## Response to the Reviewers' Comments

The authors would like to thank the reviewers for the precious comments and suggestions on the technical contents and presentation of our manuscript "Runtime Power Management of Battery Electric Vehicles for Extended Range with Consideration of Driving Time," submitted to IEEE Transactions on Very Large Scale Integration (TVLSI.) This revised manuscript has been greatly improved thanks to the reviewers' invaluable advices. We have revised the manuscript faithfully following the reviewers's comments. We include the newly added or significantly modified parts in the revised version of the paper also in Response to Reviewers. We highlight the important technical content changes and set those parts in a red color in the revised paper.

Fig. 2: (a) Range-speed experimental data for Chevrolet Bolt [36] and (b) comparison with simulation results of the proposed EV power model.

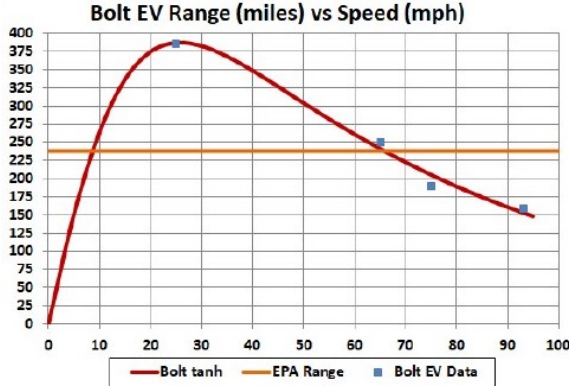
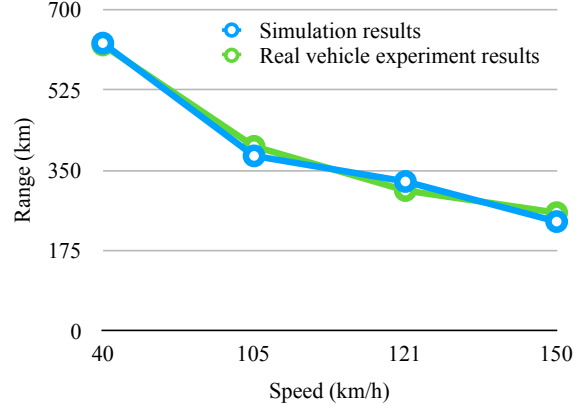
**R1-C2** It is not clear how to validate the power model of EV. As the author mentions that accuracy of power model is quite important, it is good to see the power model in this paper can be validated by some real measurement results.

We further evaluate the model accuracy with the range-speed real vehicle experiments as shown in Fig. 2(a) to confirm the derived power models are close enough to the real vehicle measurement data [32], [33], [34], [35], [36]. We refine the coefficients until all the available data values match well.

As a result, the derived EV power model well matches with the range-speed experimental data as shown in Fig. 2(b) as well as the top speed and maximum acceleration setting the aerodynamic resistance, rolling resistance, curb weight, etc. with the known values. The errors in the range-speed simulation is merely 1.4%, the time for 0-to-100 km/h error is 7.8%, and the top speed error is 3.0%, respectively.

Fig. 12: Velocity profile comparison with  $EDP$ ,  $E^2DP$  and  $E^3DP$  on Serrano Avenue in Anaheim Hills.

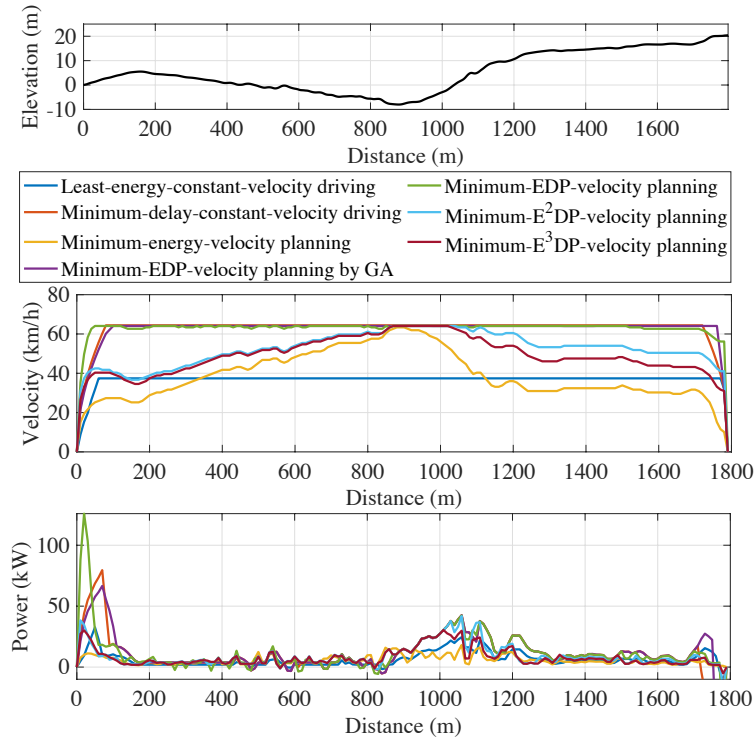
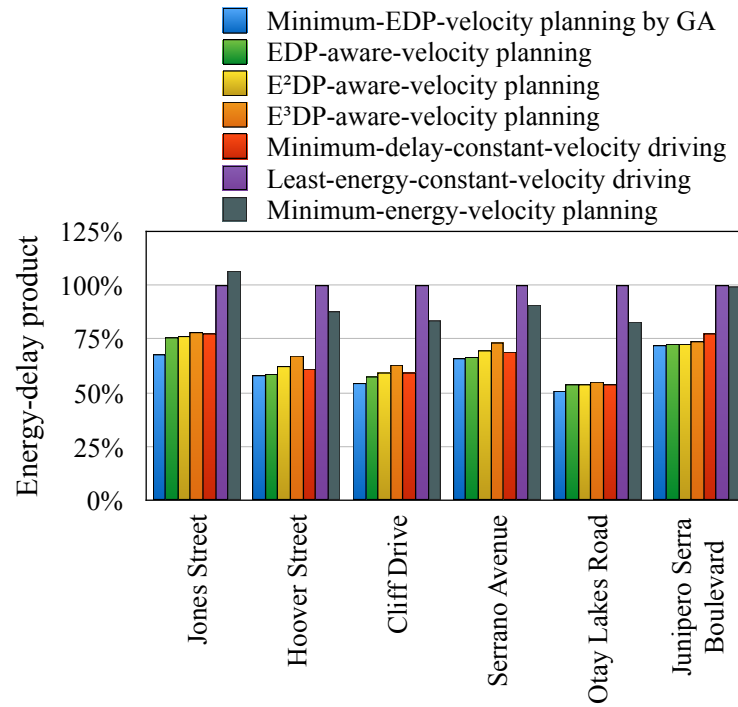
**R1-C3** The optimality of the proposed scheduling algorithm is unclear. The author should add several paragraphs to discuss this topic. It is also to see the comparison baseline is well accepted to show the advantage of the proposed algorithm.

Fig. 12 summarizes  $EDP$  of the least-energy-constant-velocity driving, the minimum-delay-constant-velocity driving, the minimum-energy-velocity planning, the velocity planning with  $EDP$ ,  $E^2DP$  and  $E^3DP$  as a metric on the road benchmarks and the minimum- $EDP$ -velocity planning with GA. The proposed velocity planning results in up to 46.2% improvements of  $EDP$  compared with the least-energy-constant-velocity driving. The driving velocity on a flat road is faster than that of the least-energy-constant-velocity driving at the expense of relatively little energy to save driving time. Then, the velocity decreases when climbing the following uphill to spend less motor torque, which saves more energy.

In addition,  $EDP$  of the proposed EDP-aware-velocity planning is merely 4.3% higher than that of the true EDP-minimum-velocity planning on average. Through this results, we confirm that the results of the proposed heuristics are close enough to the true optimal solutions.

We also updated Fig. 12 and Fig. 13:

Fig. 11: Histograms of velocity and acceleration for the proposed energy-aware-velocity planning methods without an acceleration constraint (a) and (b) and with an acceleration constraint (c) and (d), respectively.

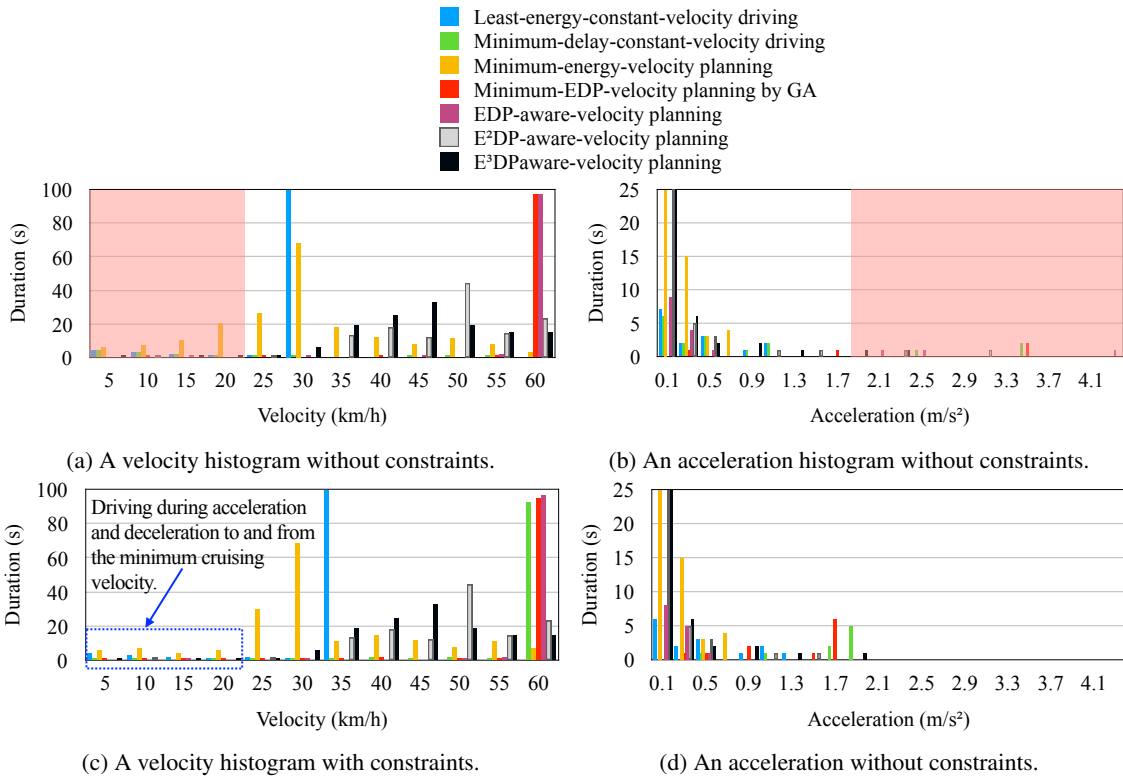
**R2-C2** It would be good to have more discussion on the assumptions of the approach and the experiments, e.g., how much can the velocity be changed in practical scenarios without impeding traffic and causing unsafe situations (also depending on the road conditions and whether it is urban or rural environment I suppose). Currently, there only seems to be one constraint on not slower than 10 km/h.

Fig. 11(a) and (b) show two histograms of the driving schemes in Fig. 12, which do not have velocity and acceleration constraints. We avoid a cruising velocity lower than 25 km/h and an acceleration higher than  $2.0 \text{ m/s}^2$  in this paper without loss of generality. The acceleration of  $2.0 \text{ m/s}^2$  is the same as the maximum acceleration of compact cars designed to be used primarily used in urban areas (13 seconds of 0 to 100 km/h time).

Fig. 11(c) and (d) shows the velocity and acceleration histograms with the constraints. Once we run the DP for the first time without constraints, we analyze the histogram, adaptively determine the minimum cruising velocity and maximum acceleration constraints, and run DP again. We keep the same constraints for online recomputation whenever unexpected interrupts occurs.

We quantize the velocity and acceleration values and make a histogram to analyze population of velocity and acceleration for the proposed energy-aware-velocity planning methods. Fig. 11(a) and (b) show two histograms of the driving schemes in Fig. 12, which do not have velocity and acceleration constraints. We avoid a cruising velocity lower than 25 km/h and an acceleration higher than  $2.0 \text{ m/s}^2$  in this paper without loss of generality. The acceleration of  $2.0 \text{ m/s}^2$  is the same as the maximum acceleration of compact cars designed to be used primarily used in urban areas (13 seconds of 0 to 100 km/h time).

Fig. 11(c) and (d) shows the velocity and acceleration histograms with the constraints. Once we run the DP for the first time without constraints, we analyze the histogram, adaptively determine the minimum cruising velocity and maximum acceleration constraints, and run DP again. We keep the same constraints for online recomputation whenever unexpected interrupts occurs.

Fig. 8: Altitude changes in the real road benchmarks.

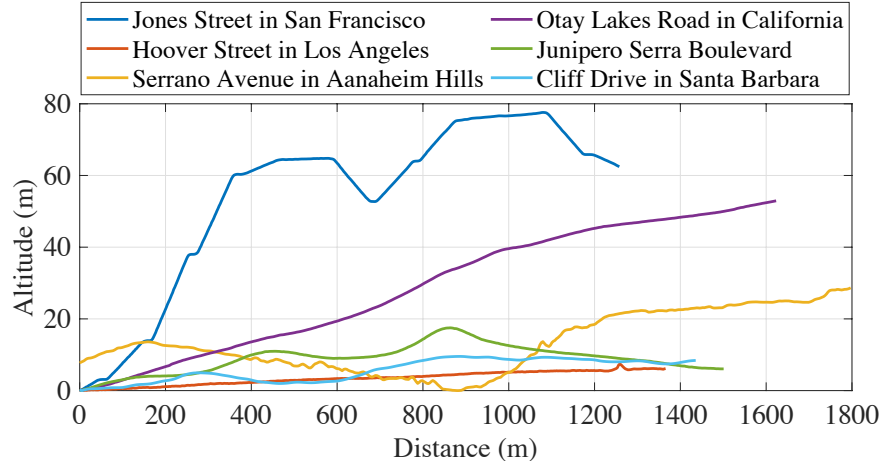
**R2-C3** Related to the last point, it would be good to have more discussion on the road benchmarks, e.g., how they are generated and how representative they are. The optimization results significantly depend on road slope. It would be good to use a variety of real road segments for testing.

**R2-A3** We appreciate the reviewer's comment. We replaced the previous synthetic road benchmarks with the real road benchmarks. We made six new real routes from various locations in California. The first three roads are in cities. Jones Street in San Francisco and Hoover Street in Los Angeles are two representative city landscapes such as hills and flat roads, respectively, and Cliff Drive in Santa Barbara is a mixture of those. The second two roads are in mountain areas: Serrano Avenue in Anaheim Hills and Otay Lakes Road in San Ysidro Mountain in California. The last road is Junipero Serra Boulevard connecting San Francisco and San Jose. The details of

road data is summarized in Table II, and Fig. 8, which visualize the altitudes of the road benchmarks. We also revised all the associated contents with the new real road benchmarks.
